100GBASE-BR40: Updates to Tables

June 12, 2024

IEEE Ad Hoc Meeting

160.10.1 Optical fiber cable

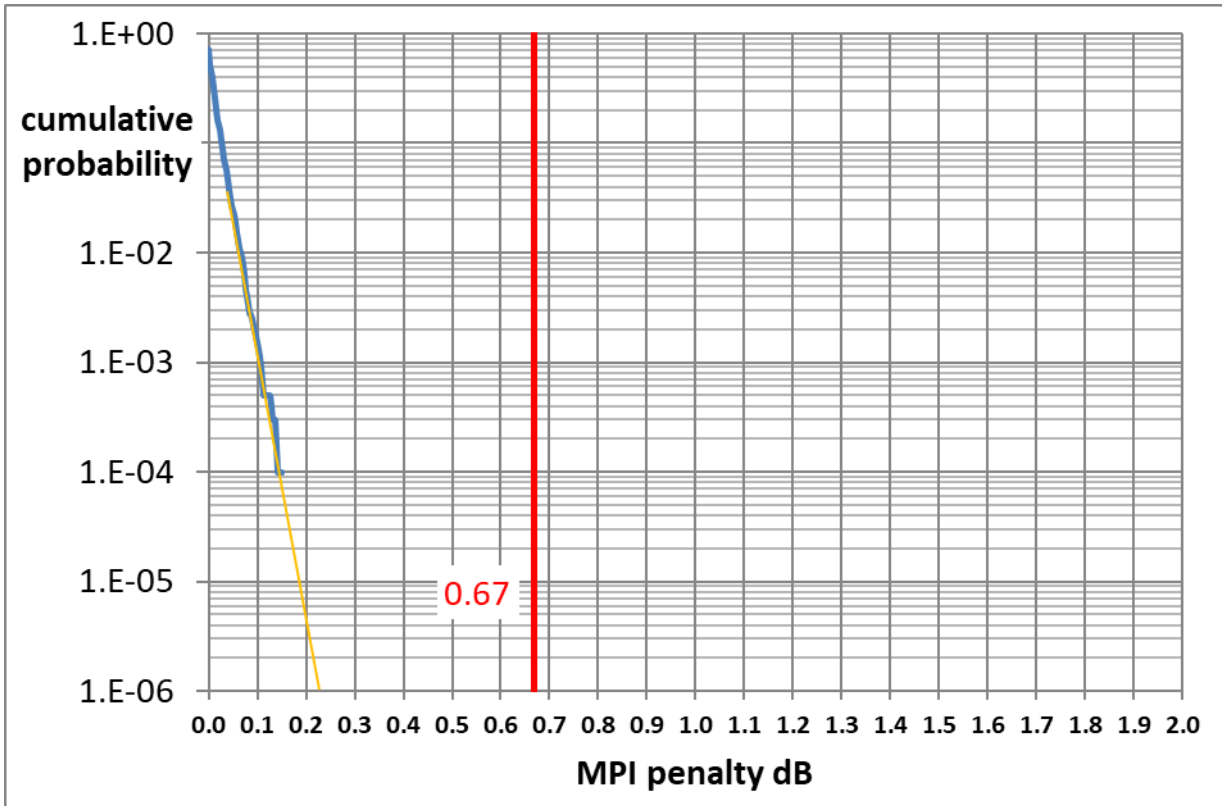
Is this a correct reference? Should it refer to the optical fiber and cable characteristics (above)? Not the channel, which is the table on the preceding slide?

DGD Penalty

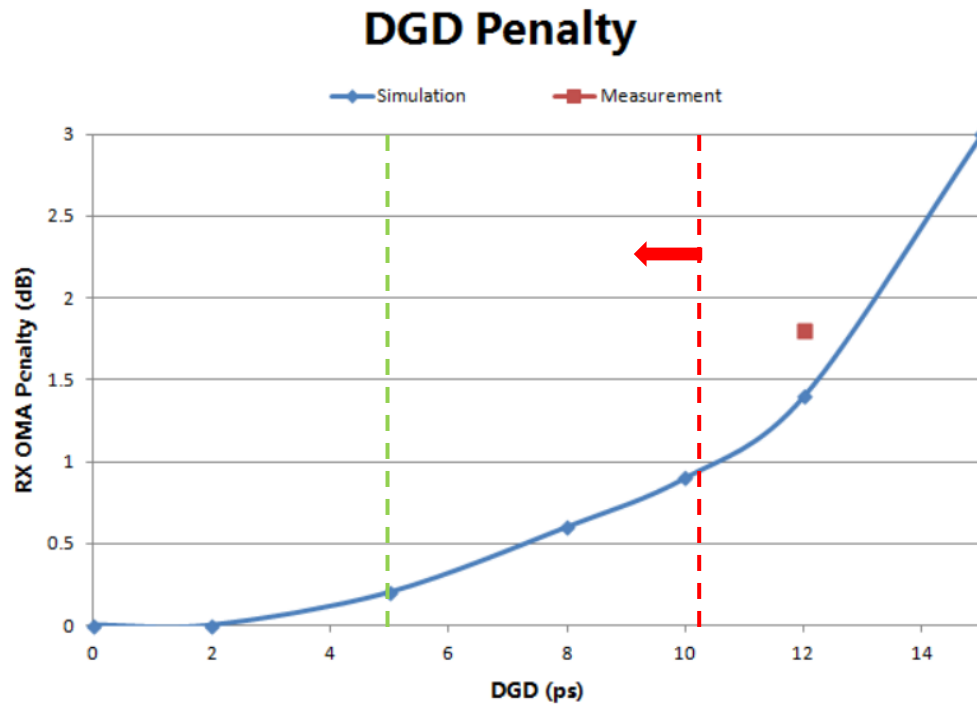
- Most current standards use DGD_max = 10.3 psec.
 - Leads to unacceptably high penalty (see plot below)

For n = 20 (20 cable segments), this evaluates to X_Q = 0.203 ps/√km
 For a 40 km link and with a ratio of “Max” DGD to mean DGD of 3.75, this is a DGD_max of **4.8 psec**. {close to April presentation of 4.9 psec}

From plot at left 4.8 psec => **0.25 dB penalty**
